UNITED STATES PATENT AND TRADEMARK OFFICE

APPLICATION NO.	FILING DATE	FIRST NAMED INVENTOR	ATTORNEY DOCKET NO.	CONFIRMATION NO.
10/656,324	09/08/2003	Bor Yann Chuang	BHT-3117-157	9202
7590	11/02/2005		EXAMINER	
TROXELL LAW OFFICE PLLC 5205 LEESBURG PIKE, SUITE 1404 FALLS CHURCH, VA 22041			SELF, SHELLEY M	
			ART UNIT	PAPER NUMBER
			3725

Office Action Summary	Application No.	Applicant(s)
	10/656,324	CHUANG, BOR YANN
	Examiner	Art Unit
	Shelley Self	3725

DETAILED ACTION

FIG. 9

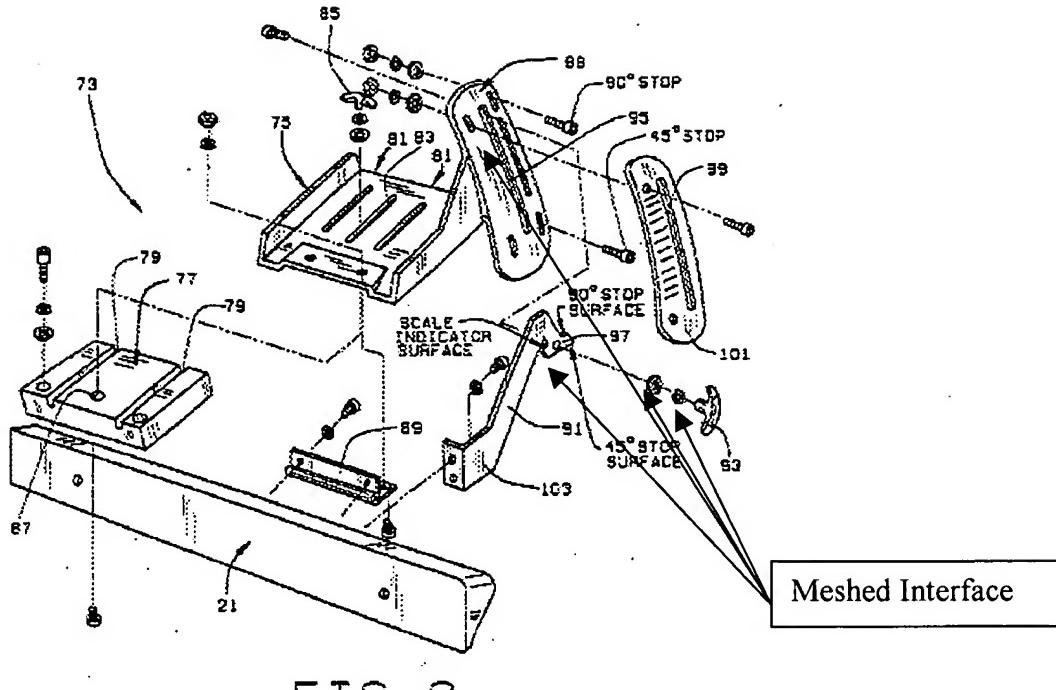
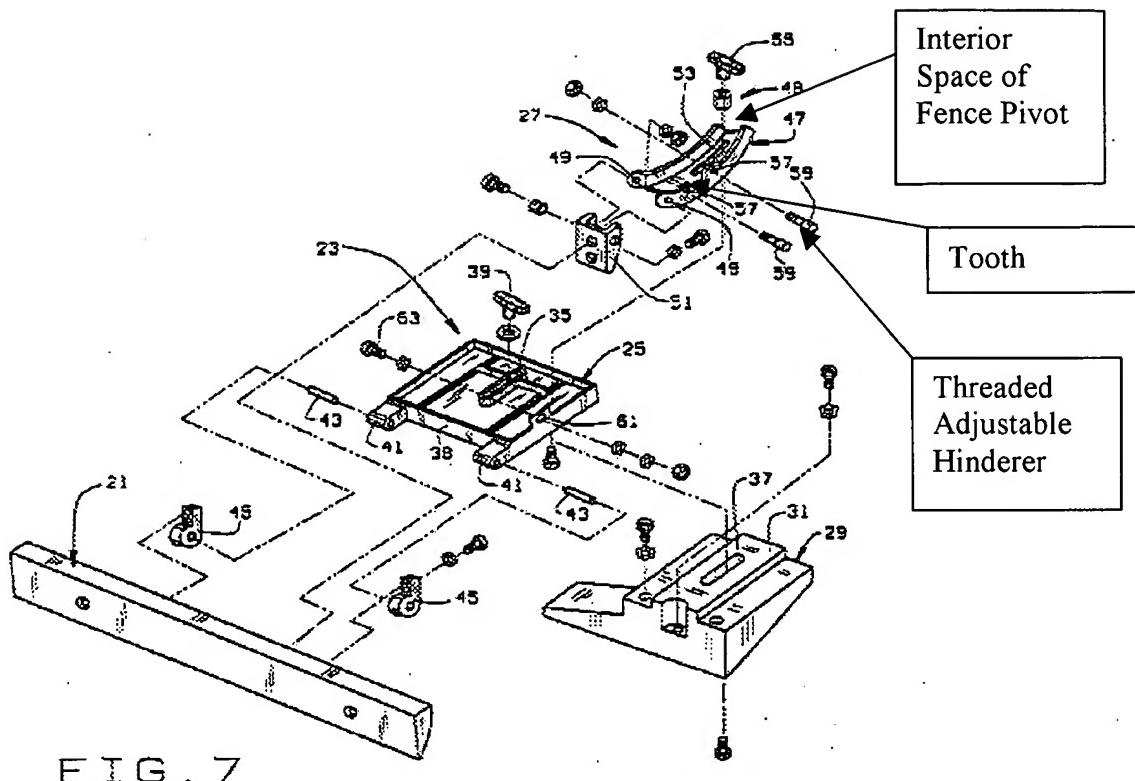
With regard to claim 10, as best as can be understood, Jedlicka discloses the drive mechanism includes components having a meshed interface (fig. 9), which cooperate to adjust the angle of the stop plank. Examiner notes, *meshed to be defined as working contact.*

Examiner notes the actuator (93) has a projection portion which meshes with cooperating structure so as to be coupled to the lever (91) of the drive mechanism (75, 89, 91) so as to cooperate to adjust the angle of the stop plank via movement of the actuator (93) and rotation of the hinge (89) affixed to the stop plank (21) resulting in adjustment of the angle of the stop plank (fig. 9).

With regard to claim 18 as best as can be understood, Jedlicka discloses the actuator (93; fig. 9) may be rotated in a clockwise or counterclockwise direction to make micro-adjustments (col. 7, line 67 to col. 8, lines 1-7) to the angle of the stop plank (21).

With regard to claim 19 as best as can be understood, Jedlicka discloses a display (101) for indicating the angle of the stop plank (col. 7, line 67 to col. 8, lines 1-7; fig. 9, scale indicator surface).

With regard to claim 20 as best as can be understood, Jedlicka discloses indicia (fig. 9; 101) and an index (fig. 9; scale indicator surface of lever 91).
